### Walarah 2 Coal Project

**WALLARAH 2 COAL PROJECT (R024/14)  
WYONG SHIRE COUNCIL RESPONSE TO PAC QUESTIONS**

**WALLARAH 2 COAL PROJECT**  
**RESPONSE TO LETTER FROM THE PLANNING ASSESSMENT COMMISSION**  
*for*  
**Wyong Areas Coal Joint Venture**

Figure 1 Preliminary assessment of Predicted demand Vs Yield

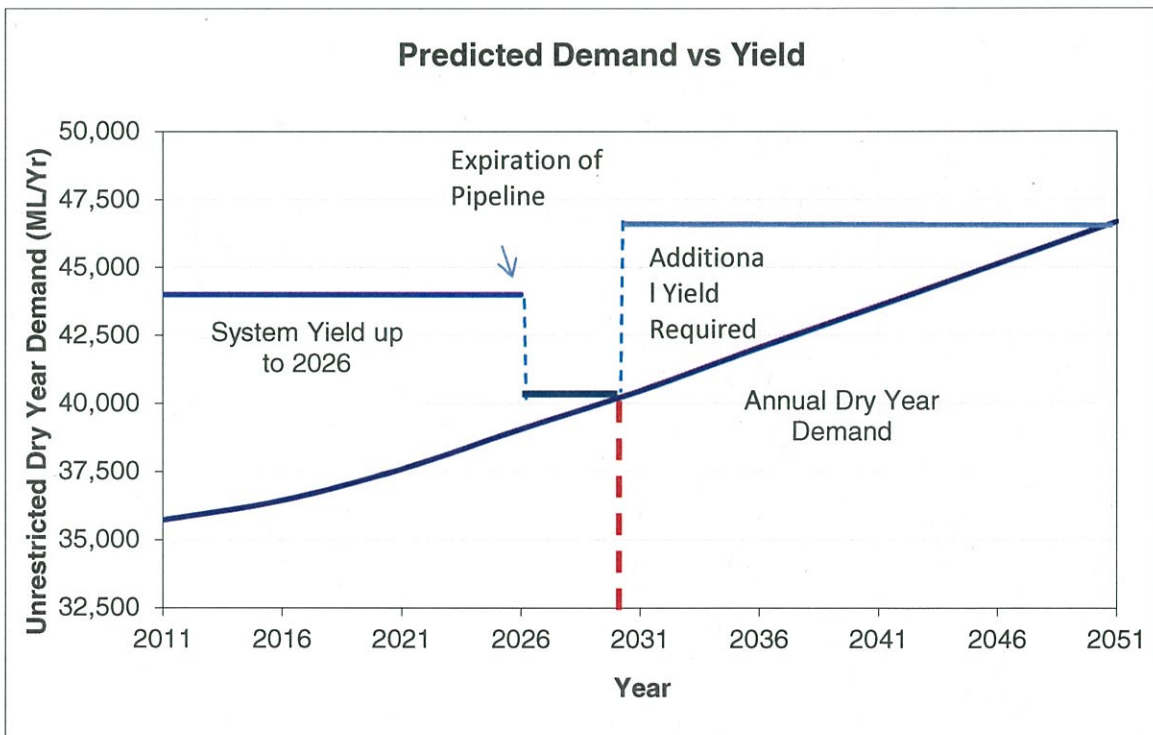
As a result of the above issues, the water supply yield is less certain than described in the 2010 PAC report. Whilst the yield currently exceeds demand, additional risks to or reductions to the yield need to be carefully considered. Refer Figure 1 - Preliminary assessment of Predicted demand Vs Yield.

No definitive solution/s have been determined at this stage to replace the system yield loss associated with the expiration of the Hunter Central Coast Pipeline agreement in 2026 nor the reduced groundwater supplies. Refer Figure 1.

Assessments as to the impact on the yield of the system related to these issues are still ongoing. Preliminary analysis indicates that the yield without a secured Hunter Connection and estimated groundwater yield reductions but the PMF restriction rectified, is in the region of 40GL/a to 42GL/a.

A yield of 40GL/a will service an estimated population of approximately 375,000, which is approximately 10 % higher than the current serviced population. Water resources are limited on the Central Coast and any reduction of water access for the supply will have a material impact on the ability to service the community.

**Figure 1**  
**Hue Hue Creek Catchment, Porters Creek Catchment and the Mine Plan**

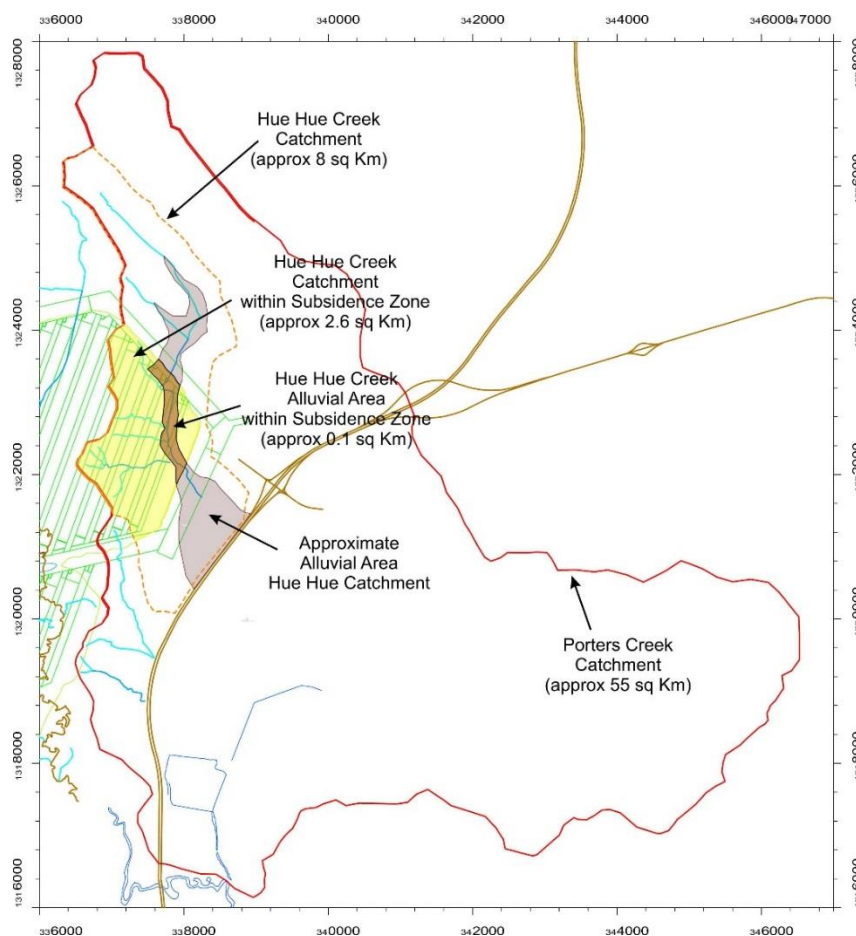
Further to the above, Council is concerned that the information provided within the 2010 EA and 2013 EIS does not adequately determine nor assess the potential impacts on the Porters Creek Wetland System.

Porters Creek Wetland (located on the eastern side of the M1 Motorway) has a catchment of approximately 55km<sup>2</sup>, which incorporates much of the Hue Hue Creek Catchment. The Hue Hue Creek catchment is located within the proposed northern extraction areas of the Wallarah 2 Coal Project. The 2010 Environmental Assessment (EA) did not undertake ecological investigations to establish baseline vegetation outside of the project area, i.e. baselines of vegetation in potential downstream areas of affectation of the proposal, including Porters Creek Wetland, were not determined.

The overall catchment for Porters Creek is approximately 55 km<sup>2</sup>, of which the Hue Hue Creek catchment contributes 8.2 km<sup>2</sup>. Approximately 2.6 km<sup>2</sup> the Hue Hue Creek catchment will be affected by mining, of which approximately 0.1 km<sup>2</sup> is alluvium (see **Figure 1**). This small area of the Hue Hue Creek alluvial system that will be subject to subsidence does not feature surface bedrock in the channel. In fact, borehole data indicates that the alluvium in the affected area is up to 17m in depth.

Hue Hue Creek drains this relatively narrow and elongated catchment. For most of its length, and for the entirety of its length within Subsidence Impact Limit, this ephemeral creek channel is relatively poorly defined and is positioned within the narrow strip of alluvial floodplain generally delineated by the 1 in 100 year flood extent. Within the Project Boundary, Hue Hue Creek is a second order stream under the Strahler stream classification system (based on 1:25,000 scale mapping).

**Figure 2**  
**Predicted Subsidence Contours near Hue Hue Creek**

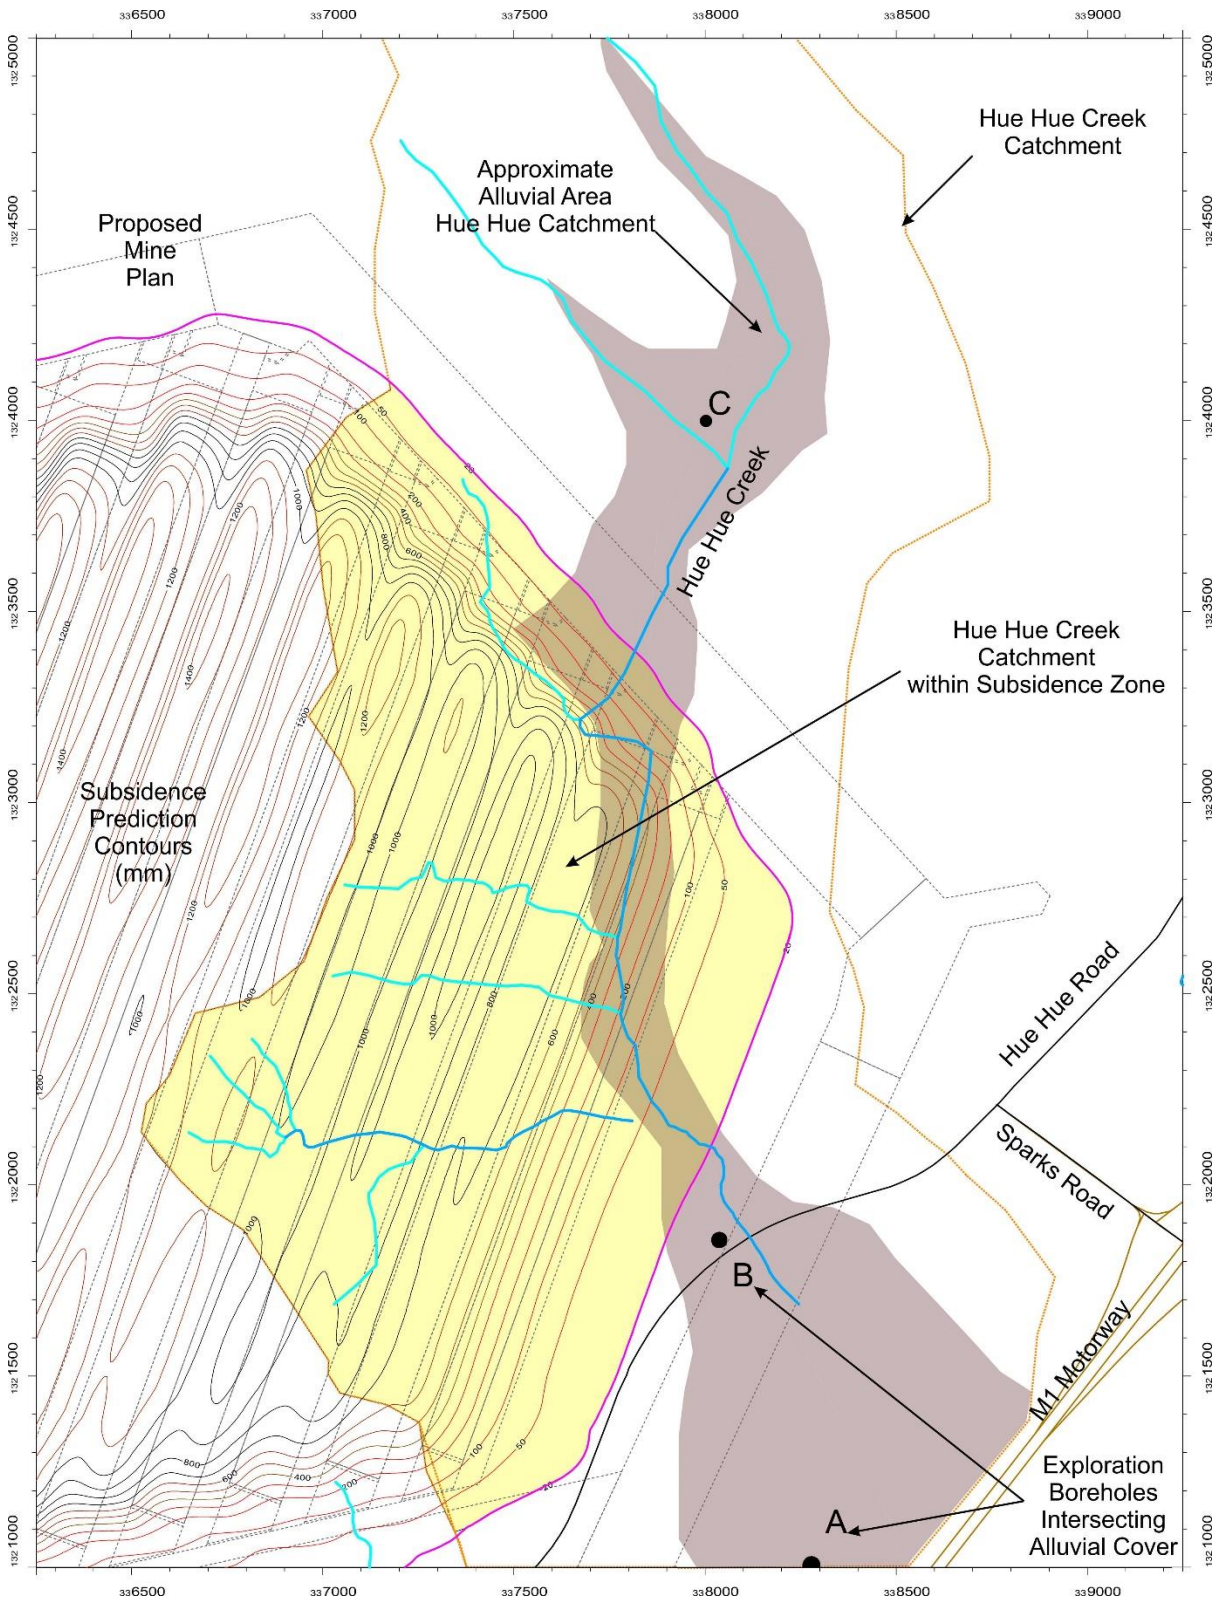
This assumption appeared to be rectified in the 2013 EIS subsidence modelling, with a specific 'Hue Hue Case' model being prepared. Despite this, the 2013 EIS failed to provide subsidence profiles for Hue Hue Creek. It also failed to establish an appropriate ecological baseline outside project area. Therefore, an assessment of the impact of the proposal on the creek, and consequently Porters Creek Wetland, could not be made.

The predicted mine subsidence profiles, as provided Appendix E of the Subsidence Predictions and Impact Assessments (Figures E.05 to E.28) are based on the conservative hybrid subsidence modelling and included profiles of the depths of cover, subsidence, upsidence and closure along each of these streams including Drainage Line A that joins Hue Hue Creek in the middle section of the subsidence affectation zone for that ephemeral stream.
